Campbelltown Road Upgrade
Traffic and Transport Modelling -
Peer Review

Traffic and Transport Modelling - Peer Review

Issue: B 16/12/13

Client: Roads and Maritime Services

Figure 2.1: Coding of Right Turn Lane with Overspill

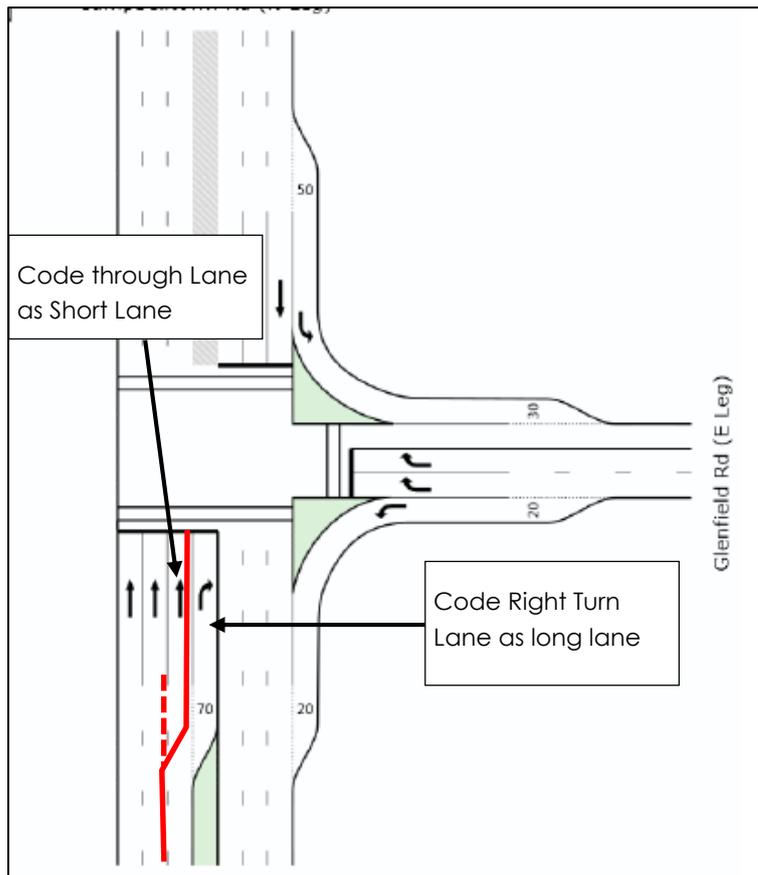
- The Degree of Saturation (DOS) of 1.0 in the AM peak is due to the right turning phase overflowing. Whilst the modelling recognises that this is an issue, the coding should have used the inside through lane as a 'de-facto' right turn lane indicating that the intersection is actually not oversaturated. This is common practice with SIDRA in these types of arrangements.

Figure 2.2: Closely Spaced Intersections

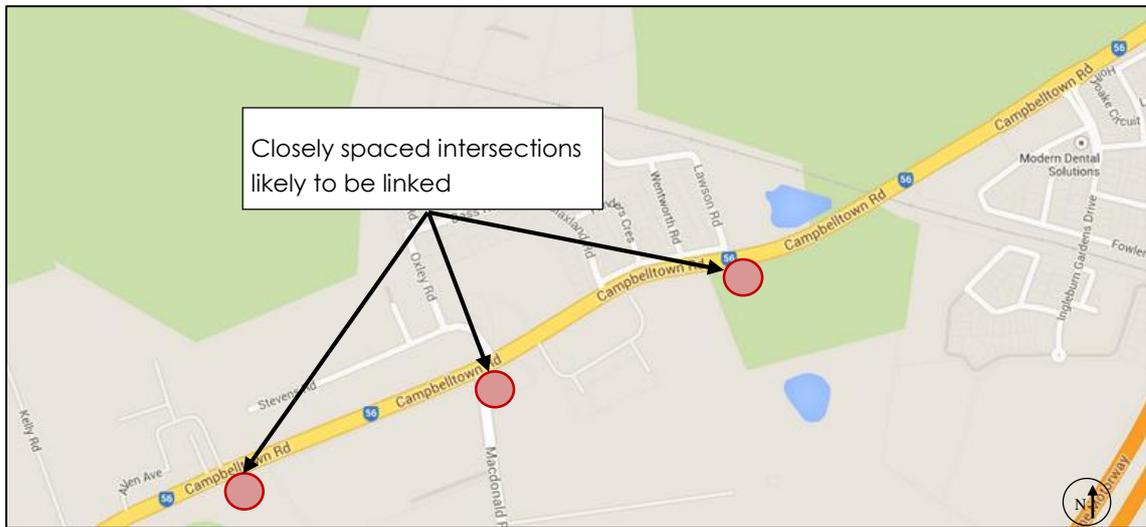
- The linking of intersections does not appear to have been considered. By 2026, the new intersection of Lawson Road, Macdonald Road and East Town Centre Road will be spaced within 400 – 500m of one another. At this spacing, it is likely that SCATS will link the operation of these intersections, requiring them to operate using the same cycle times. These are likely to be in excess of 100 seconds per cycle. As stated previously, longer cycle times result in longer queue lengths, and the anticipated volumes through this section may have downstream impacts on one another.

Figure 2.3: Application of Phase Transition

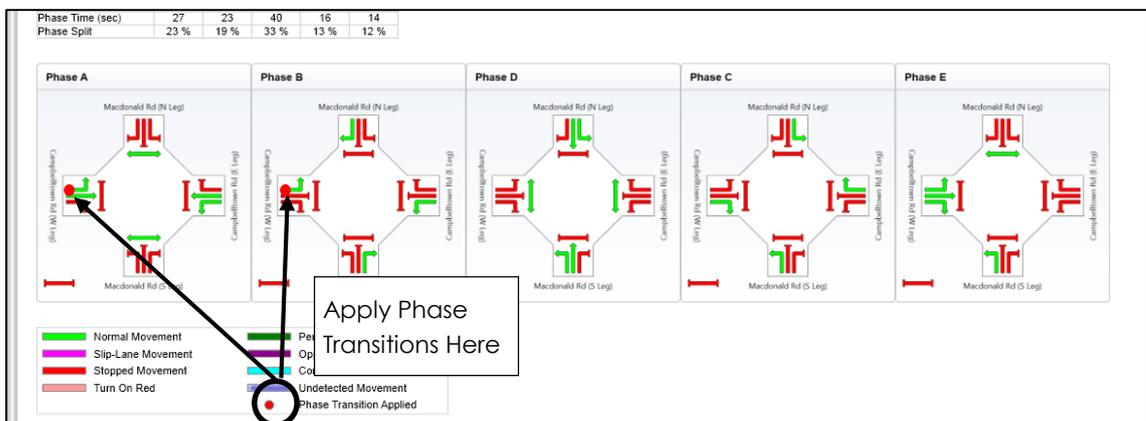
- Some of the intersections had cycle times that were manually input (assumed to be based on SCATS) whilst other intersections used the cycle time determined by the software. There are inconsistencies in the cycle times adopted across the network.
- Phase transitions should be coded into the model between phases. A phase transition is when a movement runs in two phases concurrently, the model recognises then as a continuous phase, whilst in reality they are likely to have a period of 'red' between cycles.

Figure 2.4: Proposed Campbelltown Road / Glenfield Road Intersection Layout

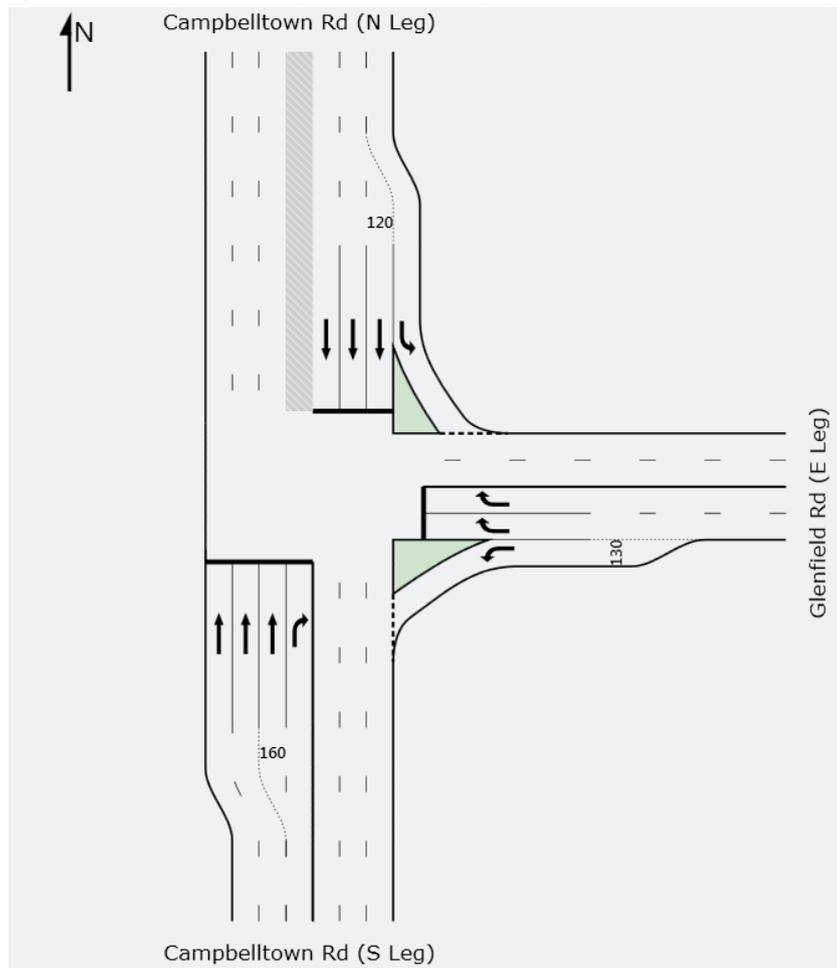
To demonstrate the impact of the issues highlighted, the intersection of Glenfield's Road in 2036 has been updated as follows:

It is clear that the changes proposed have a profound or stated impact on DOS and more importantly, queue length. This is obviously important in this regard, as queue lengths are used to determine lane lengths etc. Also, the results show that the queue length to the north may impact operation of the Camden Valley Way Intersection.

- Fully controlled right turn into Glenfield Road (noting this will be required to be confirmed on site).
- Cycle time of 152 seconds, similar to existing conditions and the likely cycle time of Camden Valley Way.
- The peak flow factor has been reduced to 95%.
- Heavy vehicle percentages have been adopted per the existing arrangement.
- The right turn volume has been increased to the existing levels (assumption).
- Signposted speeds of 70kph have been adopted.
- Re-coding of the left turn lane on Campbelltown Road north approach as a defacto normal lane and short through lane.
- Re-coding of the right turn lane on Campbelltown Road south approach as a defacto normal lane and short through lane.
- Approach type from the north as "favourable" noting that this is the off peak direction so may need some further justification.
